**RE: Town of Nottingham, Planning Board Support Services  
Review of Diberto Subdivision Proposal  
Mitchell Road, Nottingham Tax Map 7, Lot 1N  
CMA #887.9**

CMA Engineers has received the following information for this Assignment #9, review of the 14-lot single resident subdivision proposed by Robert Diberto on Mitchell Road in Nottingham (Tax Map 7, Lot 1N):

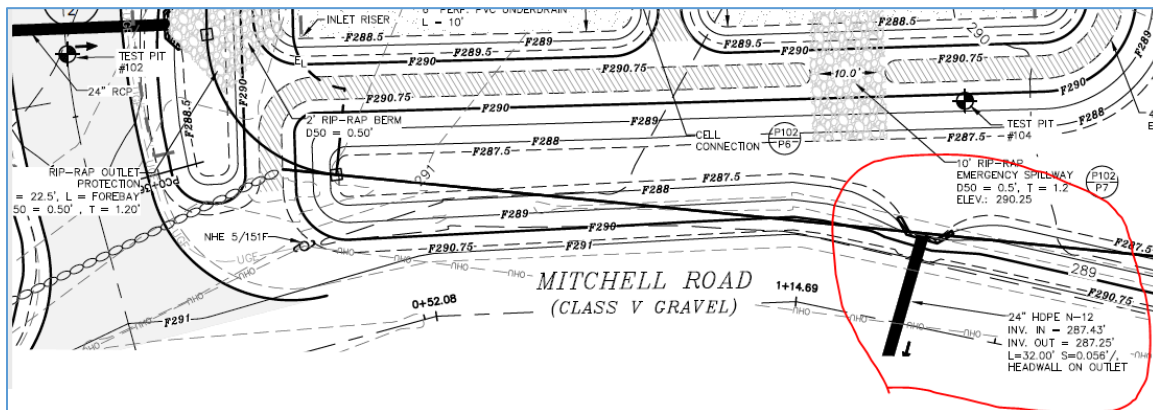
On a specific feature, the proposed replacement of the cross culvert on Mitchell Road west of the first on-site road entrance is proposed as a 24" HDPE pipe. The existing pipe is a 12" HDPE. The drainage analysis shows the discharge flows being maintained or decreased. It is not clear why a large increase is warranted. Further, it does not appear that satisfactory cover would be over the pipe. This issue should be reviewed, possibly with modifications of Mitchell Road that includes paving.
